REV :MV-01

NORN 2.0 Block Diagram

Project code : 91.4Y801.001
PCB P/N : 07243-SA
Revision : DB1

Change Notes List

ITP Connector

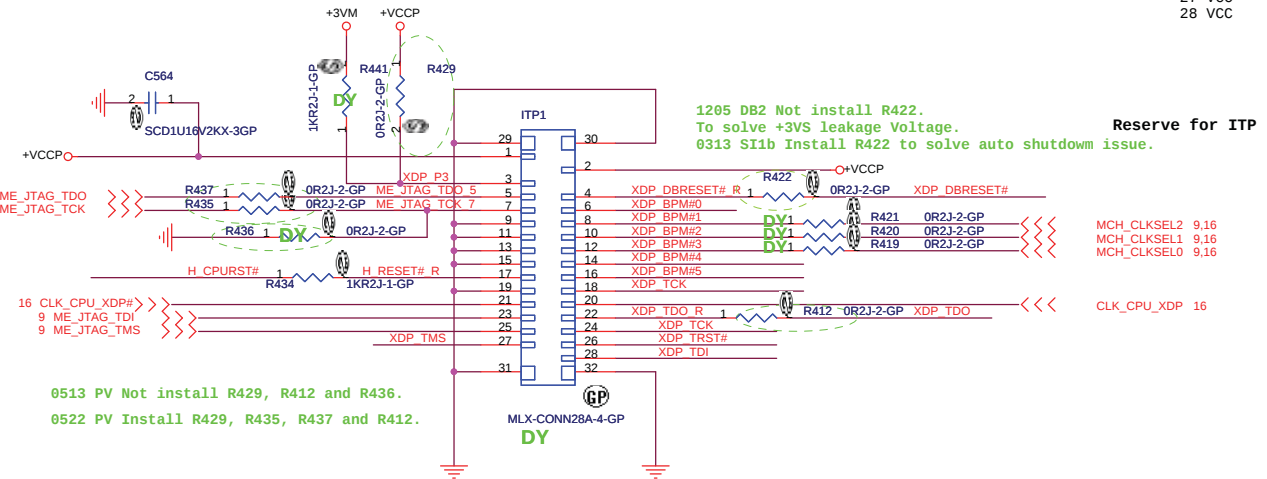
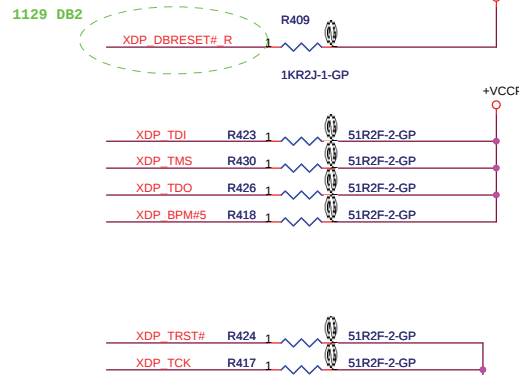
1205 DB2 Not install R422.
To solve +3VS leakage Voltage.
0313 SI1b Install R422 to solve auto shutdown issue.

LVDS CONN

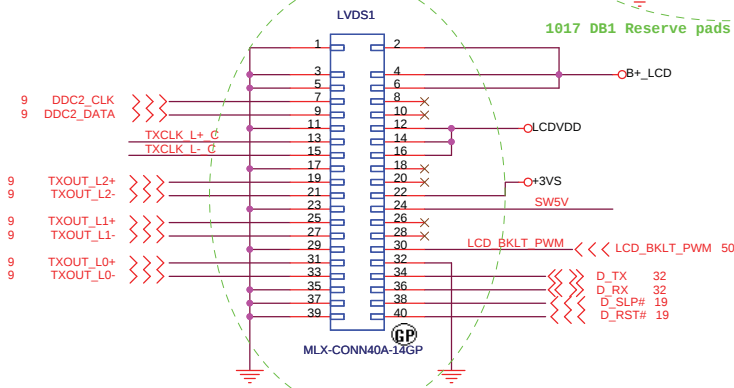
1016 DB1 Change the P/N of LVDS.

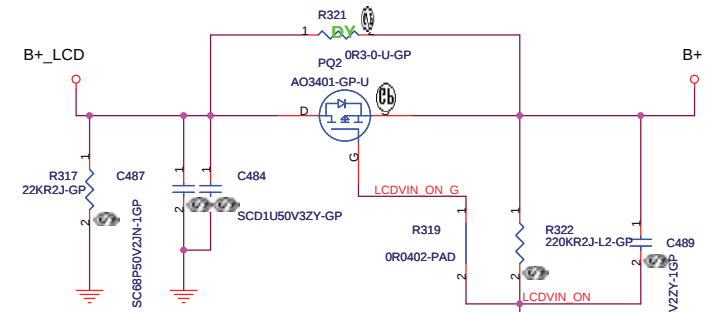
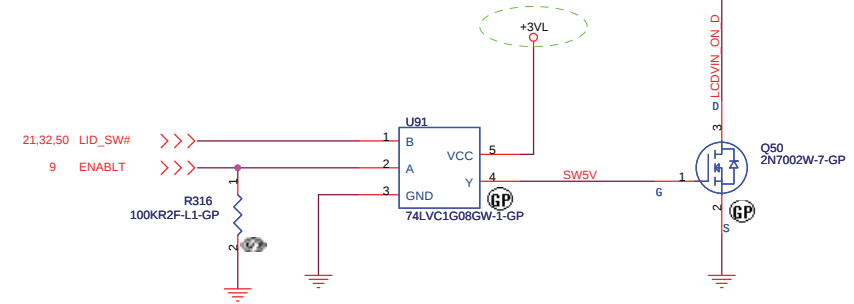
1019 DB1 Reserve C700, C710 and C711 and place near to LVDS1.

0321 SI2a To solve LCD panel lightnen when inserting power.

SATA HDD

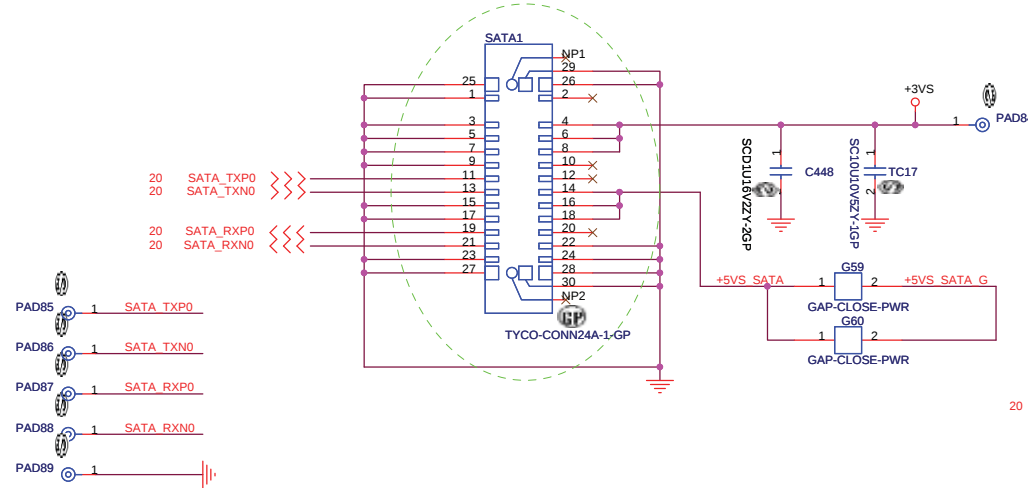
1016 DB1 Change SATA1 connector to 14 pins.
1018 DB1 Change SATA1 connector to 30 pins.
1018 DB1 Change SATA1 connector to 24 pins.

1023 DB1 Remove R384.

NEWCARD Connector

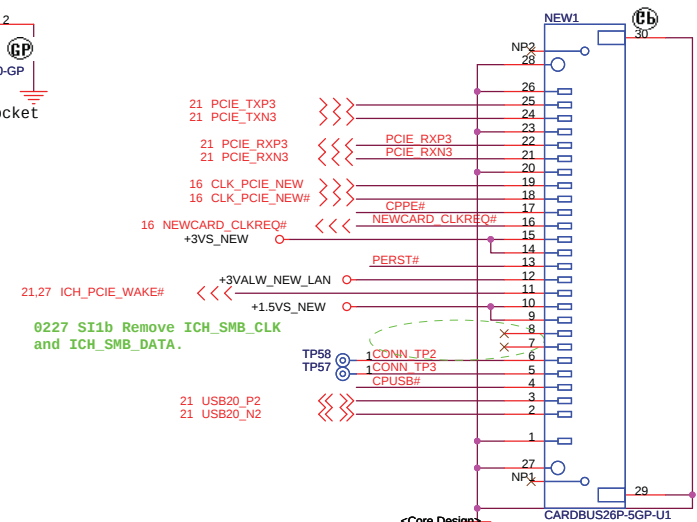
1018 DB1 No install R255 and Q21.

Power Button & LED

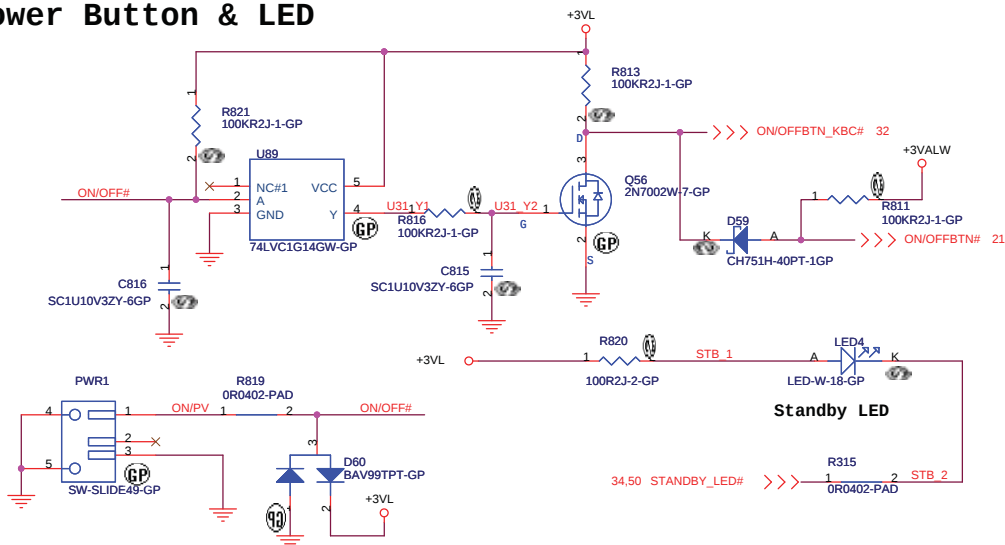
1203 DB2 Add Touch Pad ON/OFF LED circuit.

1206 DB2 Install R834.

DOCK CONN. 100 PIN

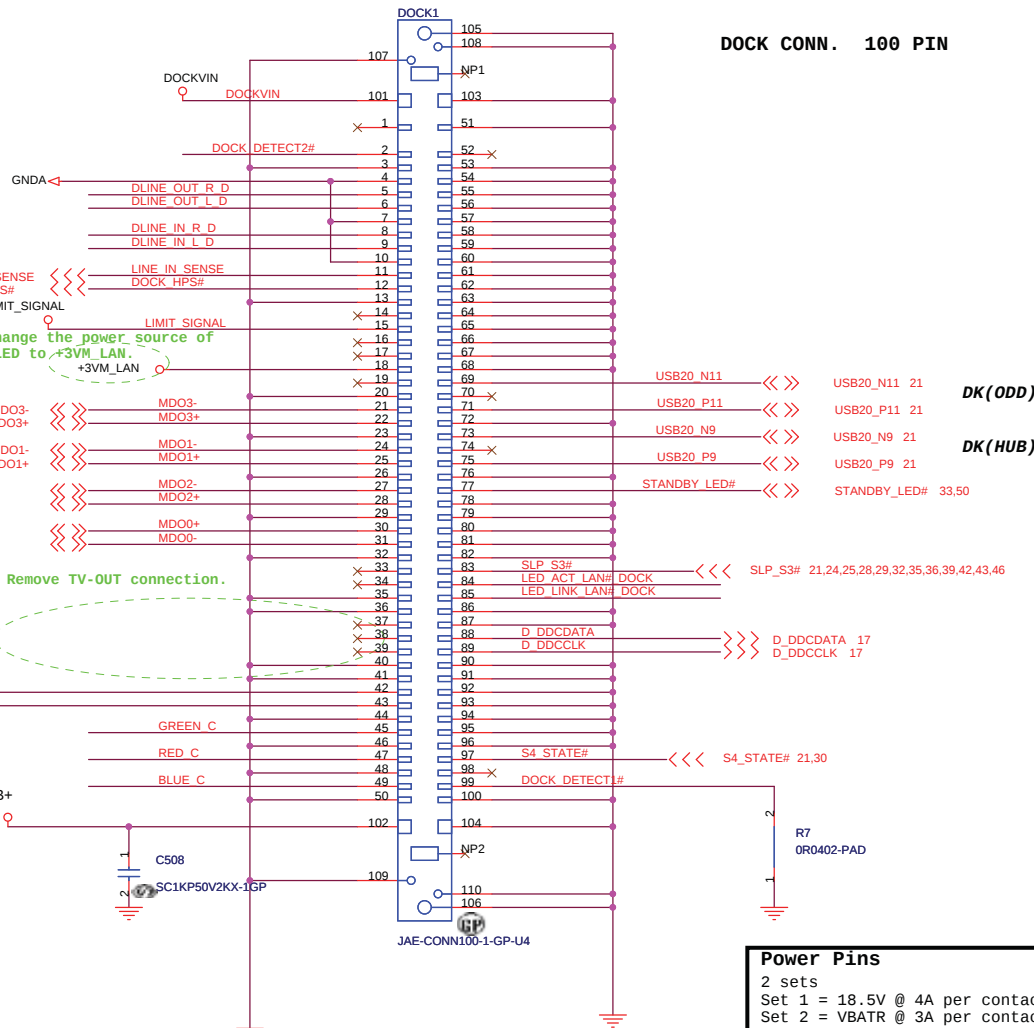
0227 SI1b Swap the connections of U3-1 and U3-6.

MAIN BATTERY CONNECTOR

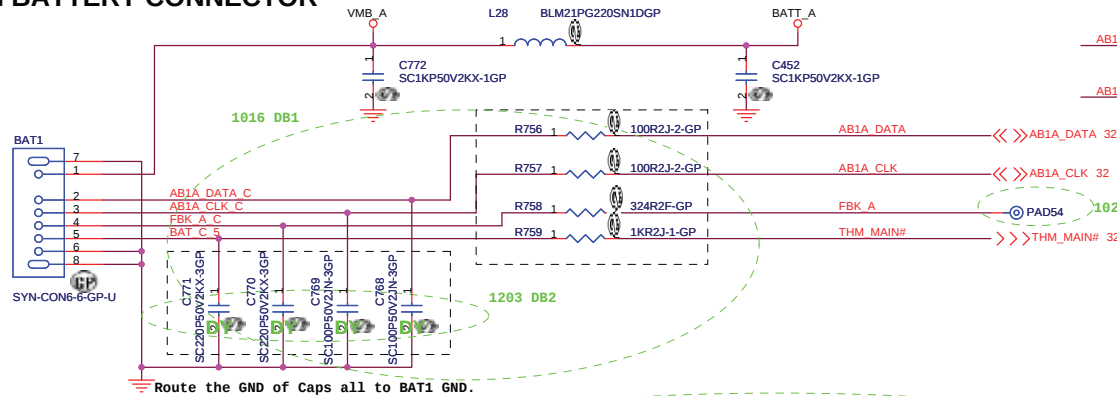
1008 DB1 Remove D74 and
move D68, D73 and D75 to Page32.

1017 DB1 Change +3VALW to +3VL.

BAY BATTERY CONNECTOR

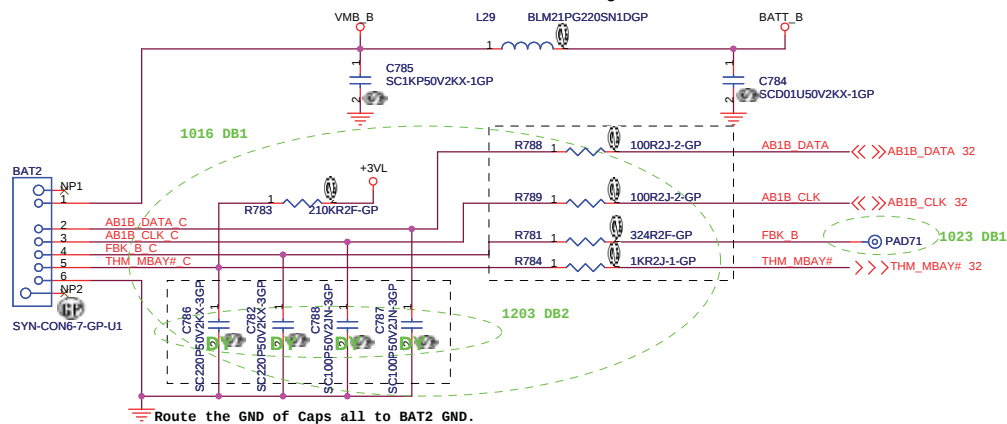
1008 DB1 Remove D77 and
move D76, D78 and D79 to Page32.

1017 DB1 Change +3VALW to +3VL.

CAMERA

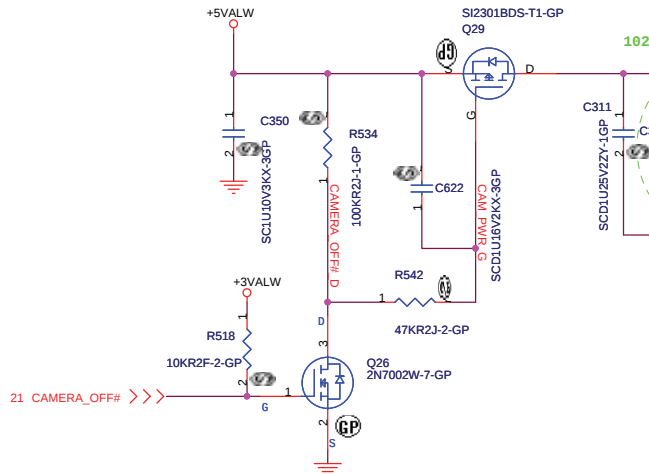
1203 DB2 Remove R167, R168, R139 and R140 pads.

FingerPrint

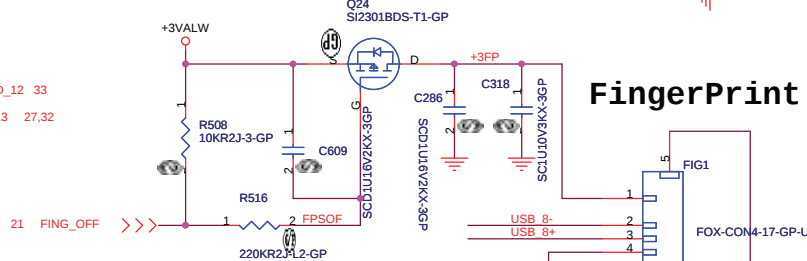
1203 DB2 Remove ESD diodes U27 and U31.
